PACIFIC SQUARE SAN GABRIEL MIXED-USE PROJECT

Final Environmental Impact Report

June 2021

Figure 2-1
Wind Rose

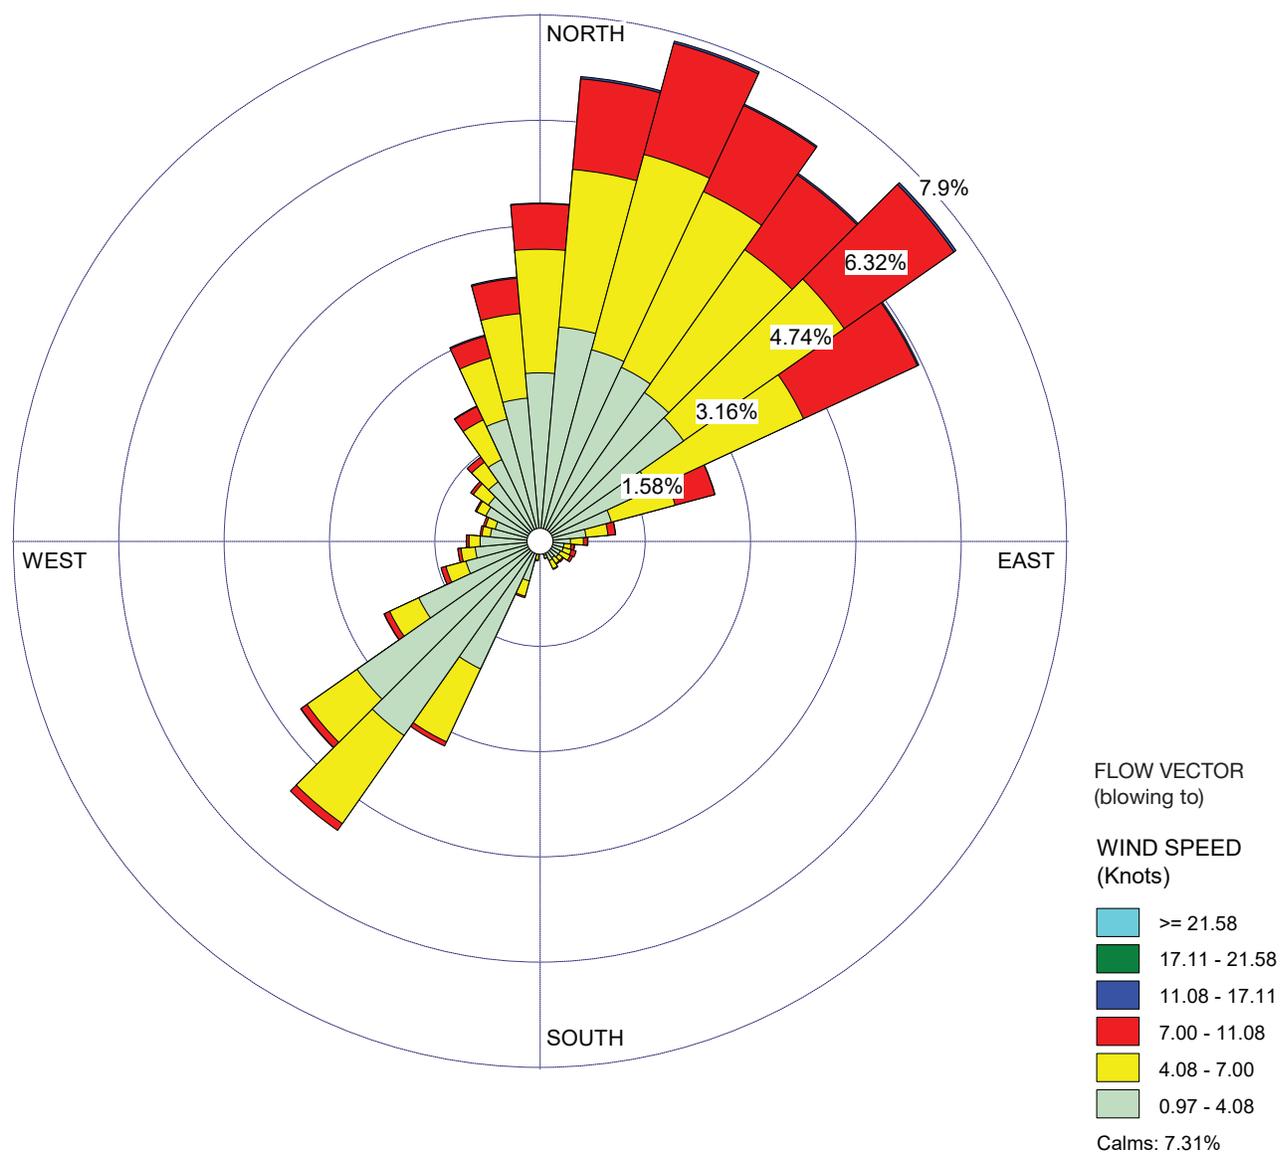
The third fatal flaw is that on page 26 of Exhibit C, SWAPE assumed Project "operational activities will generate approximately 419 pounds of DPM per year throughout operation." SWAPE calculated this value multiplying the total tons of PM10 per year (0.2096 tons per year) from their CalEEMod output by 2000. This value was calculated based on the total exhaust PM10 emissions, which includes all area, energy, and mobile source exhaust PM10 emissions in the CalEEMod operational output files provided in SWAPE Exhibit C, Attachment F. However, SWAPE

incorrectly assumes the 419 pounds of exhaust PM10 emissions are the result of diesel fuel combustion. Only a very small portion of these operational emissions are DPM. The area and energy exhaust PM10 emissions are the result of gasoline-fueled landscaping equipment and natural gas combustion for building heating and cooking. The operational mobile source exhaust PM10 emissions are from a combination of primarily gasoline-fueled vehicles, such as passenger vehicles and light-duty pick-up trucks, and a smaller number of diesel-fueled trucks as provided in the vehicle fleet percentages in the CARB on-road vehicle emissions factor (EMFAC) model. It is inappropriate and factually incorrect to analyze non-diesel fuel exhaust PM10 emissions as DPM. Doing so would result in substantially overestimated and unrealistically high health risk impacts.

Furthermore, the screening-level HRA provided by the commenter models all the DPM emissions from mobile sources as if the emissions were occurring at a single location. This is another fatal flaw because mobile sources (specifically worker, haul, vendor, and residential/employee trips), by their very nature, do not generate emissions at a single location but rather along the entire vehicle trip, which would disperse the emissions along regional roadways and not concentrate the emissions as a single location. When conducting HRAs, dispersion of pollutants is a critical and important consideration because health risk impacts are a direct result of TAC concentrations. The screening construction and operational HRA provided in SWAPE Exhibit C incorrectly assumes that all mobile source emissions would occur at a single location (i.e. on the Project Site), which results in concentrations at sensitive receptors that are artificially elevated to highly unreasonable levels. For these reasons, the health risk results in SWAPE Exhibit C are misleading and incorrect and are not supported by substantial evidence.
